Arklow Flood Relief Scheme

Report on CPO at Arklow Town Marsh and South Quay

Wicklow County Council

Report No. W3689-W-R002

Figure 3.3 – Location of Plot 101

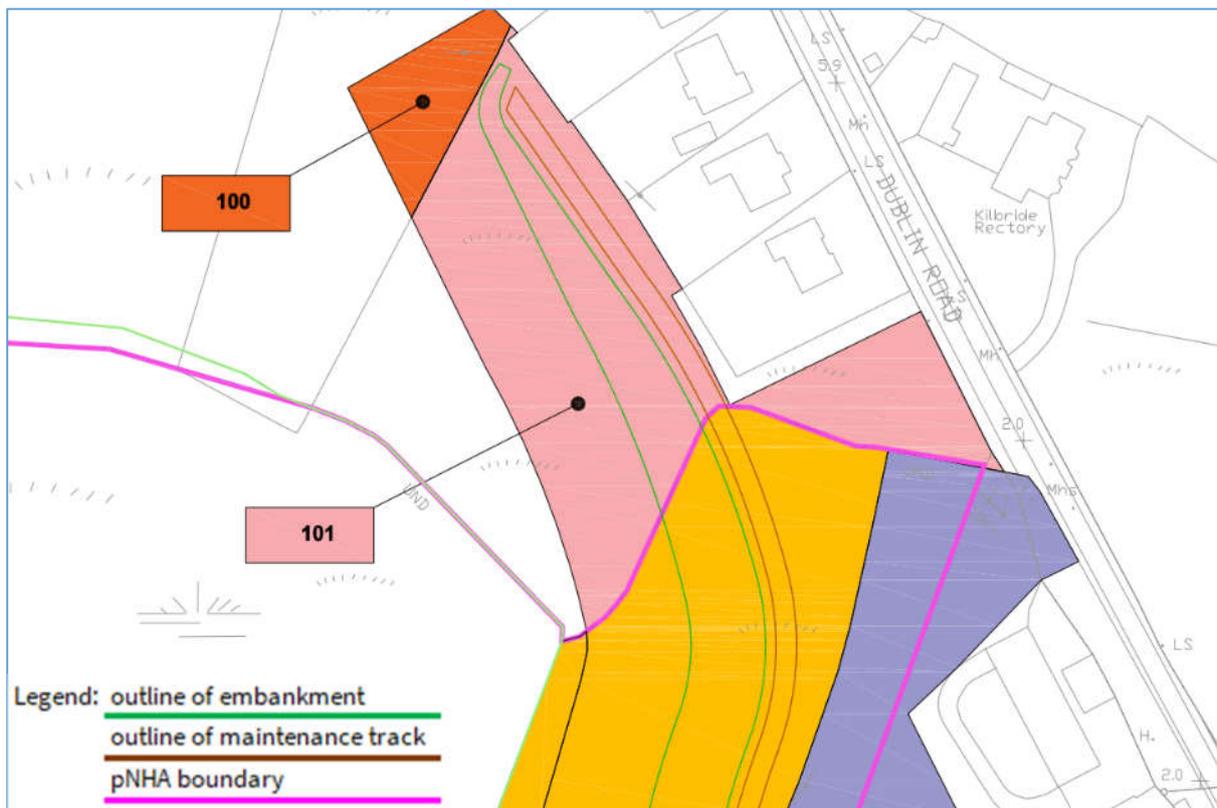
CPO-1 relates to plot 101 shown below in Figure 3.3 below. The Appellants, Patrick and Patricia Ivory, raised issues in relation to the proposed CPO with respect to:

- The extent of the land acquisition and the land requirements for the embankment.
- Permanent rather than temporary acquisition of lands.
- Boundary treatment.

The extent of the CPO in plot 101 has been determined by the land required for the embankment, the maintenance track and temporary working area. The width required for the permanent works is approximately 20m. The balance of the area is required for temporary working space.

Wicklow County Council is agreeable to changing the acquisition of the land on the marsh side of the embankment from permanent to temporary so it will be returned to the Appellants following the completion of the Scheme. Permanent acquisition will be required for the proposed permanent development including the embankment, the maintenance track and the planting area.

The proposed boundary treatments are described above in Section 3.1. As the height of the embankment is approximately 1m in the location of Plot 101, with minimal visual impact, it is considered that there is no requirement for further landscaping.

Figure 3.4 – Location of Plots 102b, 103, 104 and 106

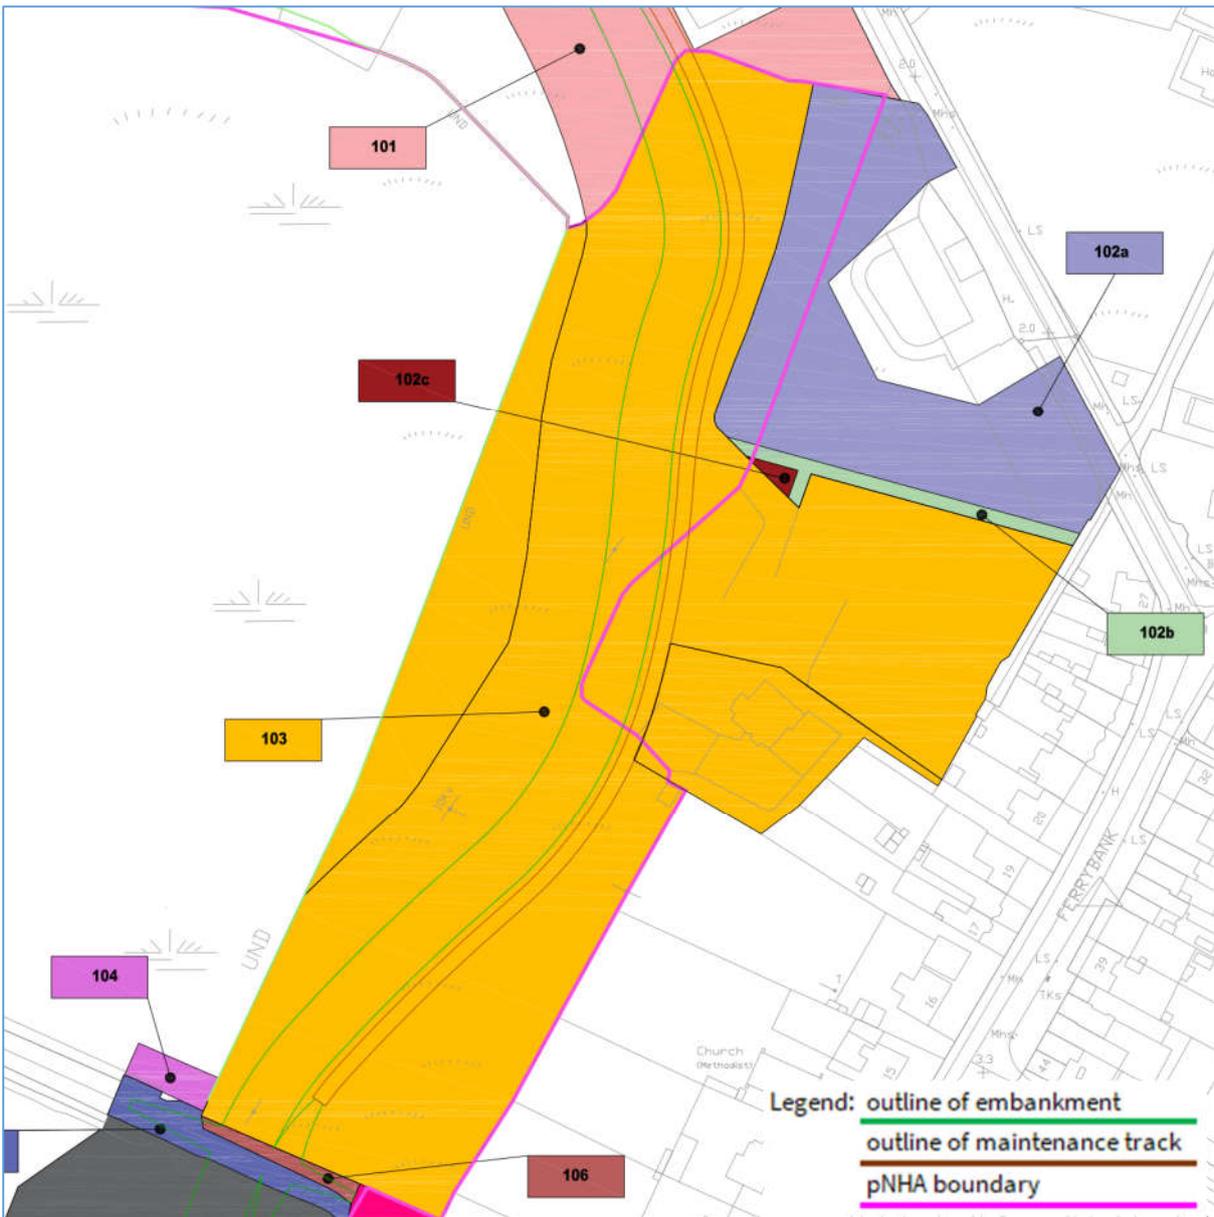
CPO-8 relates to plots 102b, 103, 104 and 106 shown in Figure 3.4 overleaf.

- Flood defence system (embankment instead of wall).
- Lack of access between remaining lands (effect on material asset).
- Tree Planting at SC1.
- Alignment of embankment.

- Permanent acquisition of land.
- Location of Site Compound (SC) 1.

The rationale for preferring an embankment to a wall at Arklow Town Marsh is set out in Sections 3.2 and 3.3 above.

The lands belonging to Prionseas O’Brionn which will lie to the west of the embankment lie entirely within the Arklow Town Marsh proposed Natural Heritage Area (pNHA). See boundary of Arklow Town Marsh pNHA in Figure 3.5 below. If access is required, then provision can be made by granting a right-of-way along the access track over the embankment to connect the two parcels of land.

The preferred location of the embankment along the edge of the marsh was determined as described in Sections 3.2 and 3.3 above and in particular, was based on minimising the impact on Arklow Town Marsh pNHA.

Wicklow County Council is agreeable to changing the proposed acquisition of the land on the marsh side of the embankment from permanent to temporary so it will be returned to the Mr

O’Brionn following the completion of the Scheme. Permanent acquisition will be required for the proposed permanent development including the embankment, the maintenance track and the planting area.

Figure 3.6 - Location of SC1

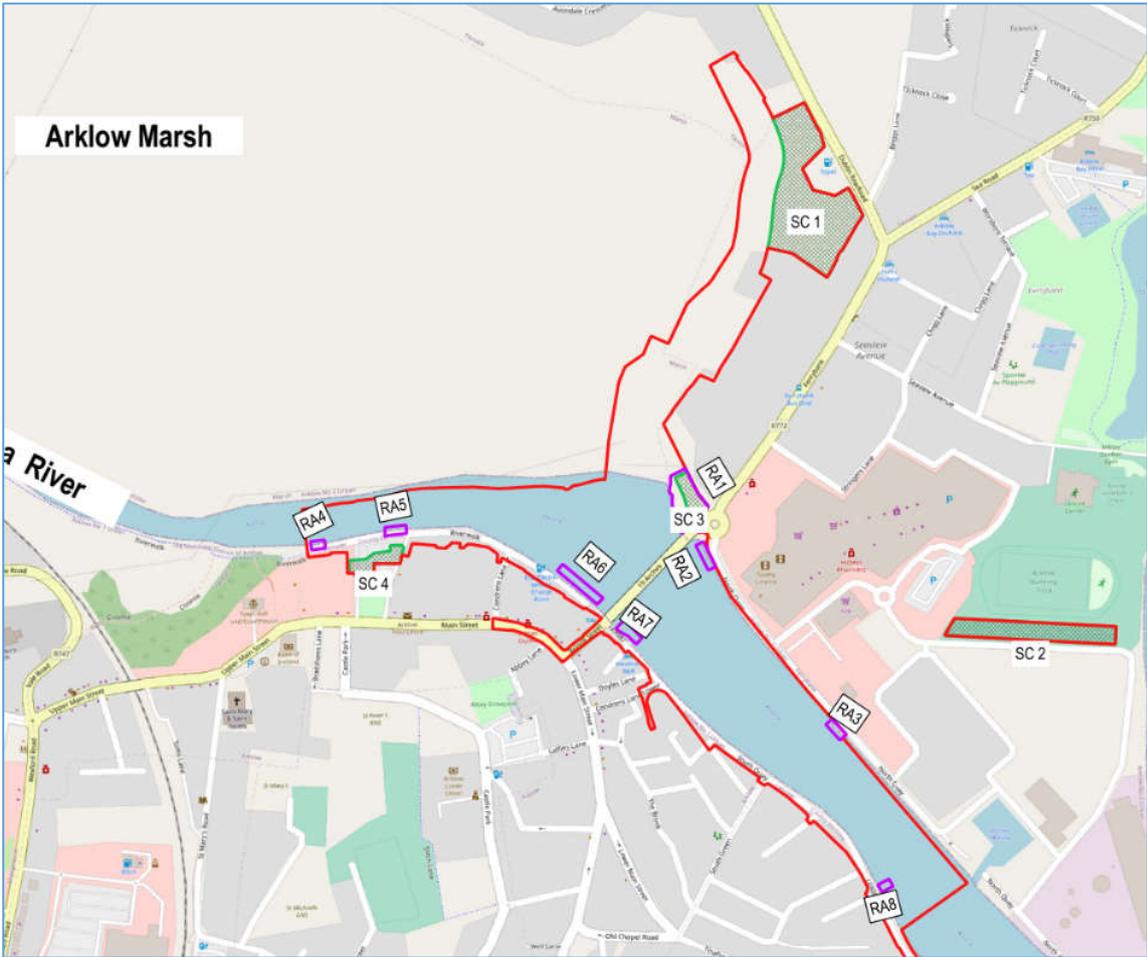
3.5.7 Location of site compound 1

Site compound 1 (SC1) is required for contractors’ site offices, welfare facilities, parking and storage. It will also be used for the archaeological monitoring and testing of the dredged material and for storing the dredged material to be reuse in the embankment. Sufficient land will be required to allow the dredged material to be spread in layers for inspection and metal detection. Based on the above requirements, the location of SC1 was selected , being a greenfield site close to the areas where dredging will be carried out and where dredged material will be reused. See Figure 3.6 below. This location will minimise construction traffic associated with transporting the dredged material from the Avoca River to a site for archaeological monitoring and testing and then to the embankment site for reuse. It also has minimal impact on existing activities at the site.

The permanent acquisition of the land is required in order to provide land for planting with native woodland species of trees in the open areas on the dry side the embankment as described in Section 3.5.4 above. This planting is proposed in mitigation for planting removed, for visual screening and integration of the embankment structure, for habitat creation and mitigation and to support the national policy for ‘No Net Loss’ as outlined in the National Biodiversity Action Plan 2017-2021 (as set out in Chapter 10 of EIAR).

Figure 4.1 - Plots 107a, 107b and 107c

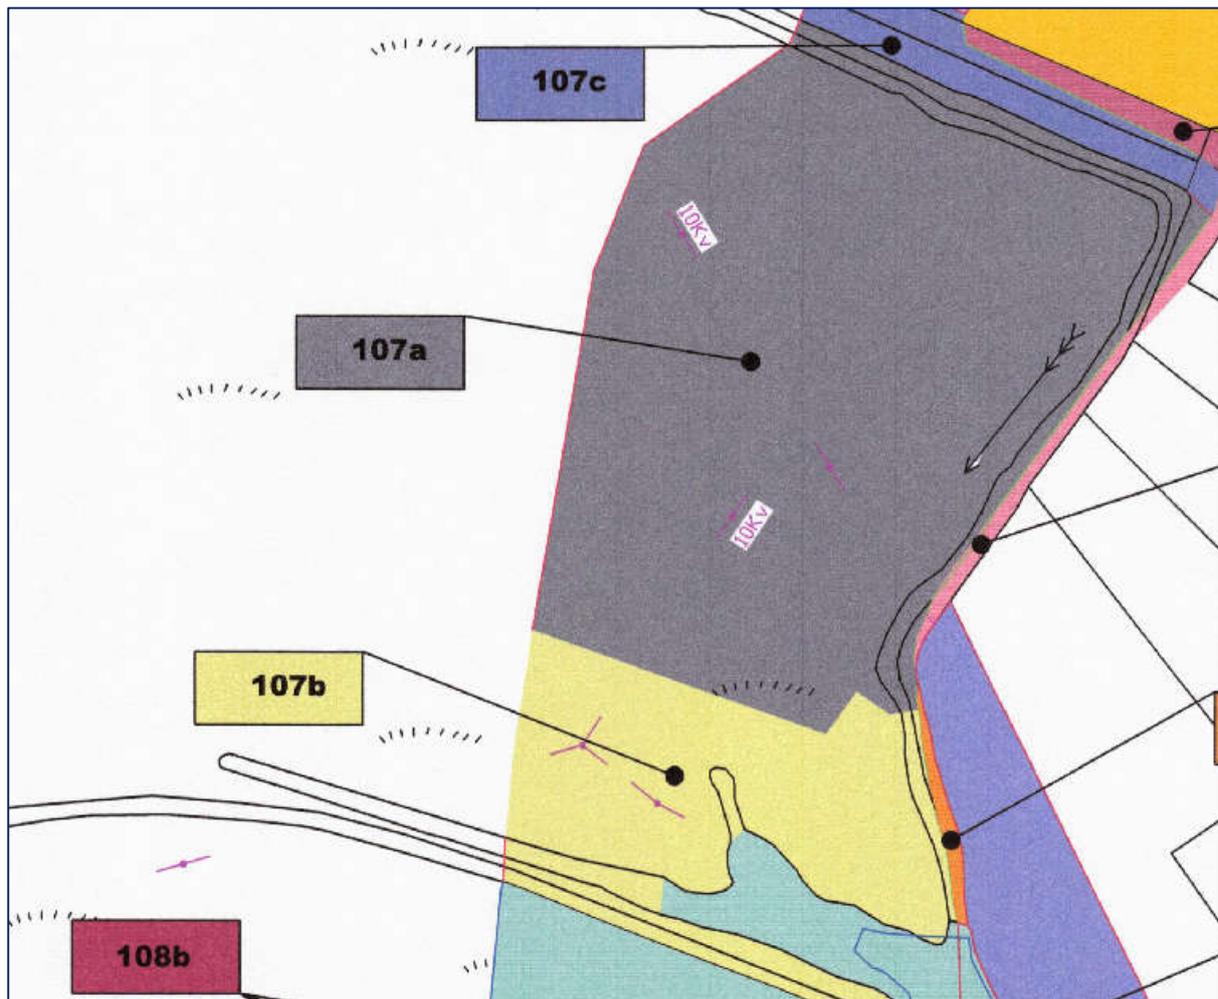
The Appellants, Graeme McWilliams and Crag Digital Above Ltd., raised issues in relation to the proposed acquisition with respect to:

- Acknowledgement of the existing right-of-way in favour of Crag Digital Avoca Ltd.
- Entitlement to alternative right-of-way on any new roadway if existing roadway is moved or altered.

The proposed development at Ferrybank is shown on Drawing 88601-1032 in Appendix 4.1 of the EIAR. From submissions received to date from the Appellants, it is not clear as to the right-of-way they are referring to. The proposed embankment will cross the existing lane running from Ferrybank to Shelton Abbey. A ramp will be provided to cross the embankment at this location, ensuring access will be maintained along the lane on completion of the proposed development, as shown in Figure 4.2 below.

WCC is not aware of any existing right-of way being extinguished but have been communicating with the Appellants to further investigate the matter. At the time of writing this report, the issue has not been clarified.

Figure 6.3 – Location of Plot 120g (circled red)

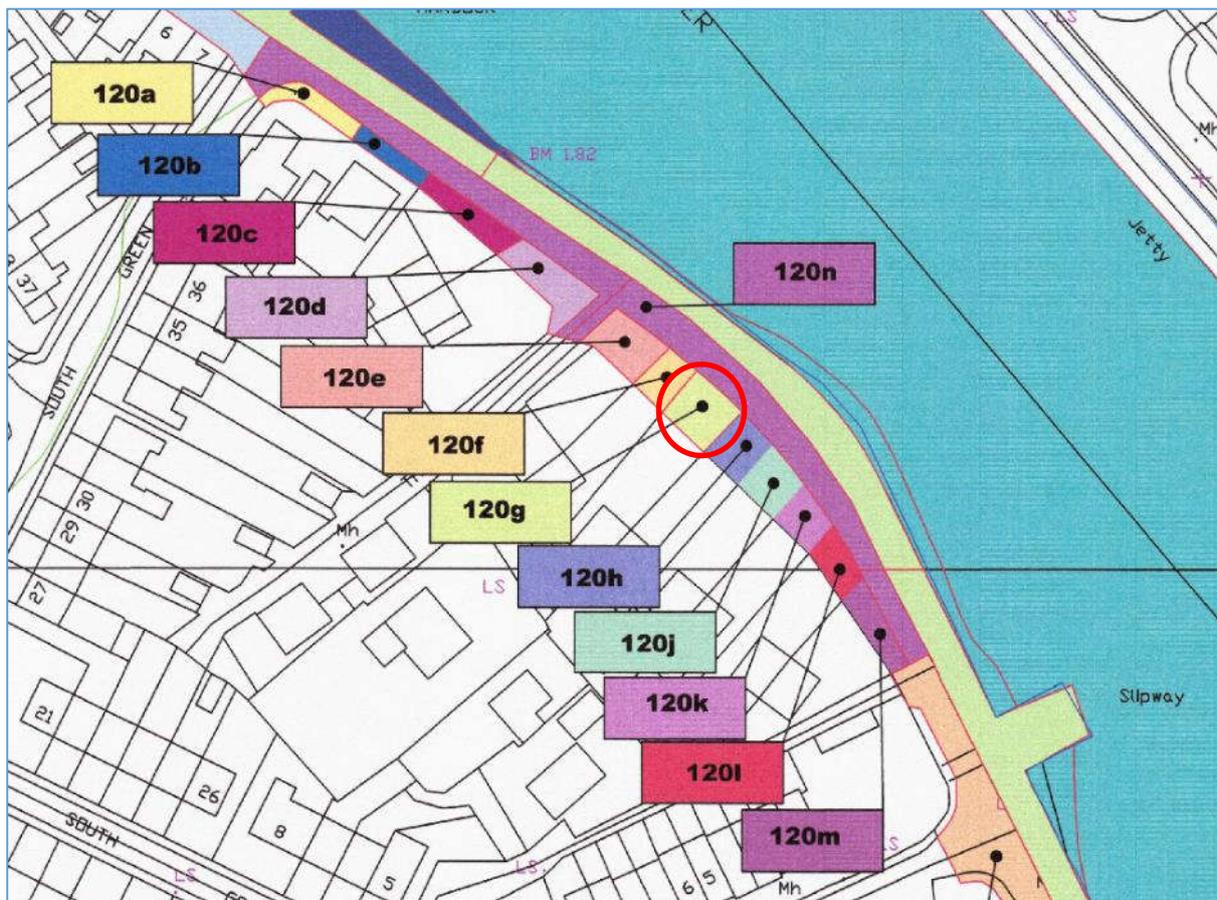
CPO-4 relates to plot 120g shown in Figure 6.3 overleaf. The Appellants, Elizabeth and Nicola Kenny, raised issues in relation to the proposed CPO with respect to:

- Occupiers of plot 120g
- Road closer to houses
- Amenity value of green area
- One-way traffic
- Hazard of new footpath
- Line of promenade by river edge
- Conflict with County Development Plan
- Removal of trees

The Appellants, Nicola and Elizabeth Kenny, are not the registered owners of plot 120g. The green areas are currently considered to be in public ownership and will remain in public ownership following completion of the Scheme. It is acknowledged that the Appellants do have private right of access from their property over plot 120g to the public road.

The edge of the public road is currently approximately 29m from the front of the Appellants' house. The proposed development will result in the edge of the road being approximately 23m from the front of the house and this is considered to be a significant distance in an urban environment.

At present, there is very little green space along South Quay. For much of its length between Doyle's Lane and South Green, there is no footpath and the existing road extends right up to the quayside or existing low wall. In several places there is car parking right beside the existing wall (see 16.3.1.2 of chapter 16 of the EIAR). The claims by the Appellants referring to a loss of green space in front of properties on South Quay are acknowledged. The green space forms a further barrier between road and properties in addition to the properties' front gardens. It is acknowledged that this environment would be changed by the proposed new landscaping, however the new landscaping is intended to enhance the amenity of the riverside and to improve the public realm, and not to diminish it. It will include a promenade for walking, retention of green areas, tree planting and seating. The road will be transformed into a more pedestrian-friendly environment and will be subject to a 30km speed limit. This will also permit more space for landscaping beside the river and for more pedestrian connectivity. Refer Figures 6.4 and 6.5 overleaf.

Traffic is considered and discussed in Chapter 7 of the EIAR. It is preferable to provide two-way roadways in urban areas as it results in lower traffic speeds, a safer environment for pedestrians and cyclists and it provides more convenient access to local properties. (Reference Section 3.4.1 Vehicle Permeability; Design Manual for Urban Roads and Streets page 53).

The Appellants state that the green area in front of their house is used by children and that it’s removal and replacement with a 2m wide footpath will result in a hazard for children, both in crossing the road and due to lack of line of sight for motorists and residents. The current situation by the Appellants’ house is shown in Figure 6.6. Clearly, the lack of a footpath on either side of the road must be considered a hazard, particularly if children are playing in the green areas immediately outside the gates of properties when vehicles are existing. The lack of formal parking could also lead to a nuisance. The unguarded edge of the river presents a hazard for motorists and pedestrians alike, including children.

The development proposals in relation to the area will provide new footpaths on each side of South Quay. The provision of the new footpath along the existing property boundary walls, including drive-ways, is a standard provision in a suburban context. It will not result in any safety implications and there is clear visibility between drivers exiting the properties and pedestrians on the footpath. The 4m distance from the wall at the front of the houses to the edge of the road will ensure that there is more than sufficient line of sight for motorists. In addition, the provision of new footpaths will remove the need for pedestrians having to walk on the existing roadway or

Figure 6.8 – Location of Plot 120h (circled red)

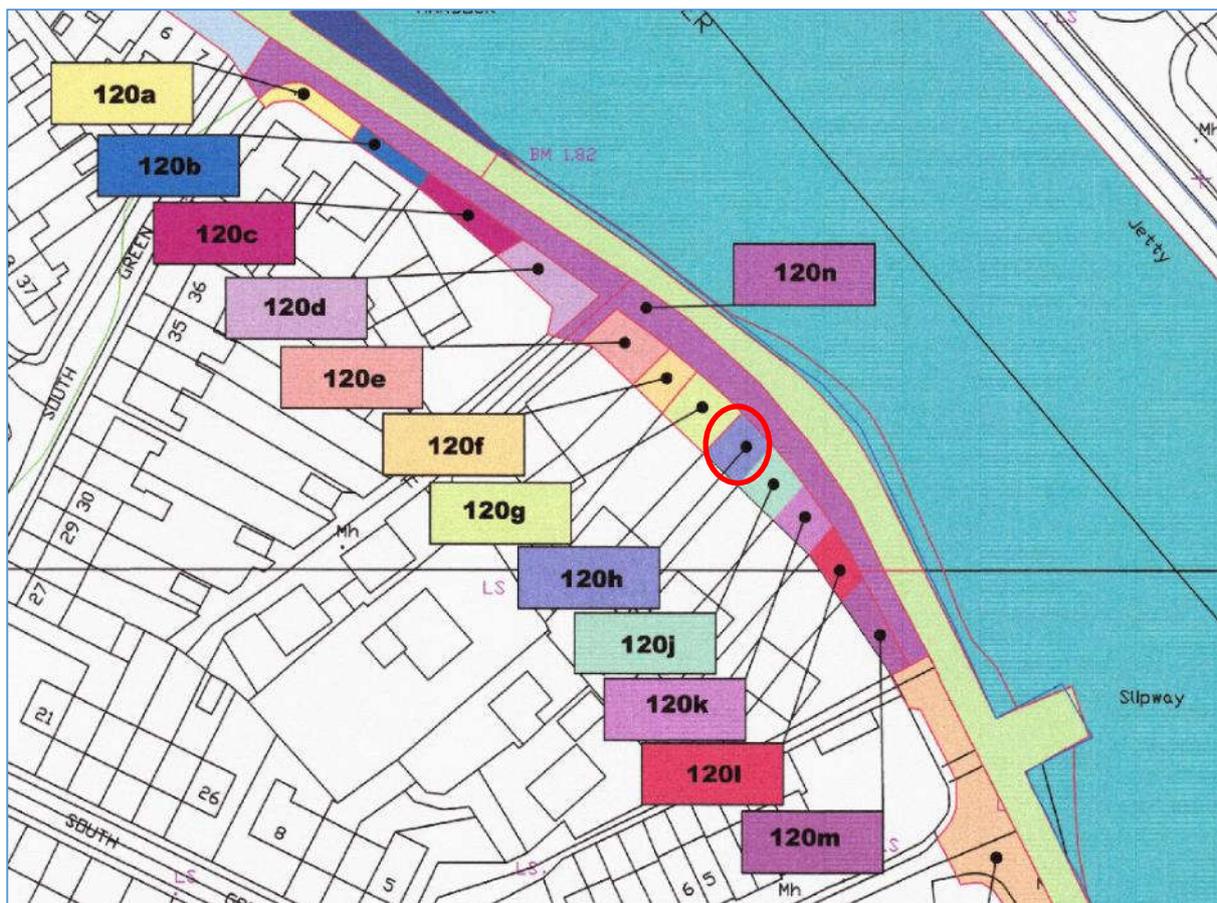
CPO-5 relates to plot 120h shown below in Figure 6.8. The Appellant, Christine McElheron, raised issues in relation to the proposed CPO with respect to:

The loss of the amenity value of the green area in front of the Appellant’s and neighbouring houses and the provision of new amenities are discussed in Section 6.4.4 above. It is considered, when the new amenities are taken into account, that there is an overall positive impact in terms of amenity in this area.

Figure 6.9 – Location of Plot 120k (circled red)

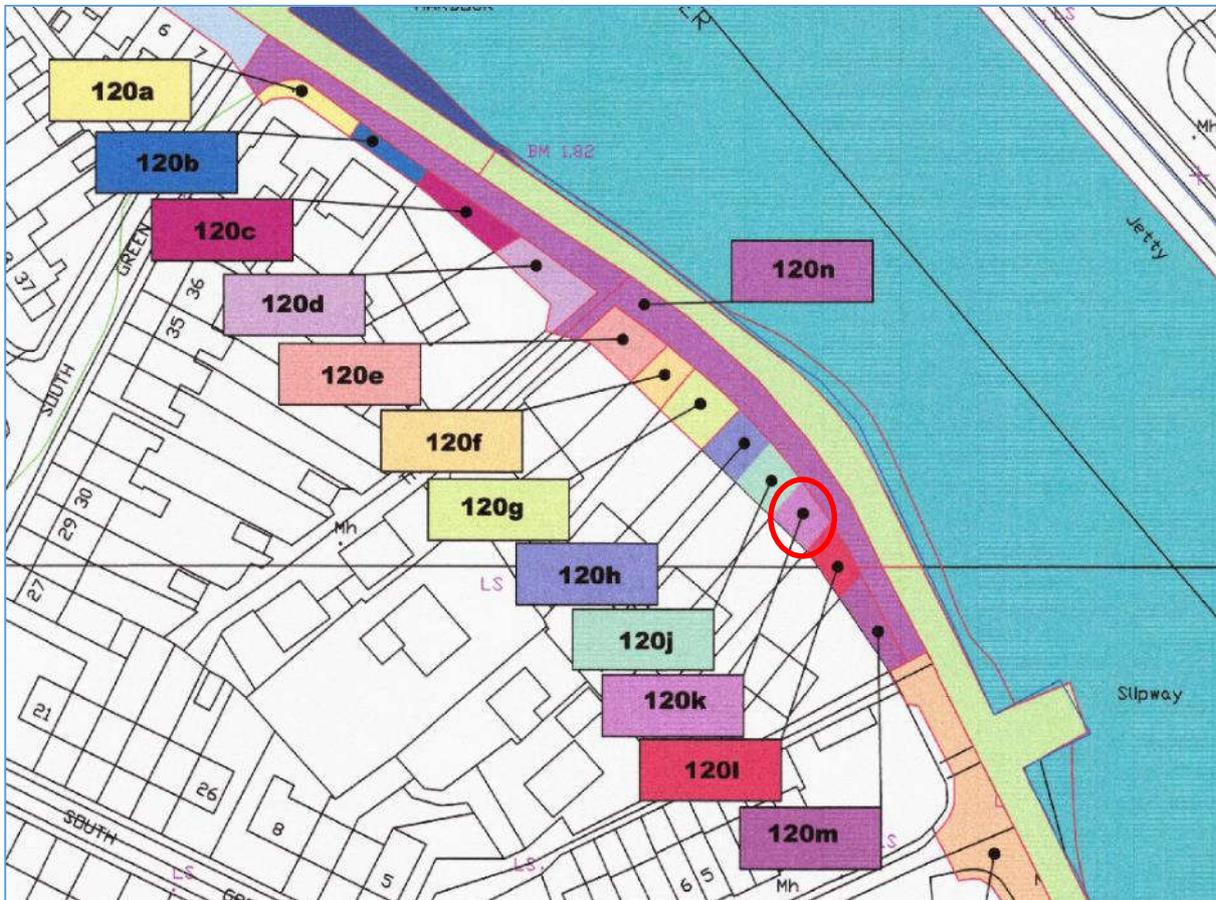
CPO-9 relates to plot 120k shown in Figure 6.9 overleaf. The Appellant, Peir Leonard, raised issues in relation to the proposed CPO with respect to:

The proposed development for South Quay, the alternatives considered and the selection of the preferred measures are described in Sections 6.1, 6.2 and 6.3 respectively above as well as in Chapters 3 (Alternatives) and 4 (Description of the Proposed Scheme) of the EIAR. Overall, the design of the Scheme sought to achieve a balance between the various competing interests while ensuring that technically the required level of flood defence is provided. The removal of the green space is required in order to provide space for:

- Retention of quay wall and 2m river edge to address requests from locals for retention of marine and cultural heritage .
- 3m wide promenade.
- Seating area by glass panels (change from original submission).
- Grass area between promenade and road.
- Grass area between road and new footpath.
- New footpath in front of houses.

The green area in front of the Appellant's and neighbouring houses does provide an amenity value. This amenity area will be replaced by alternative amenities as shown in Figures 6.4 and 6.5 above. These include:

- Retention of quay wall and 2m river edge.
- Wide promenade.
- Glass panels in wall (change from original submission).
- Seating area by glass panels (change from original submission).
- Grass area between promenade and road.
- Grass area between road and new footpath.
- New footpath in front of houses.
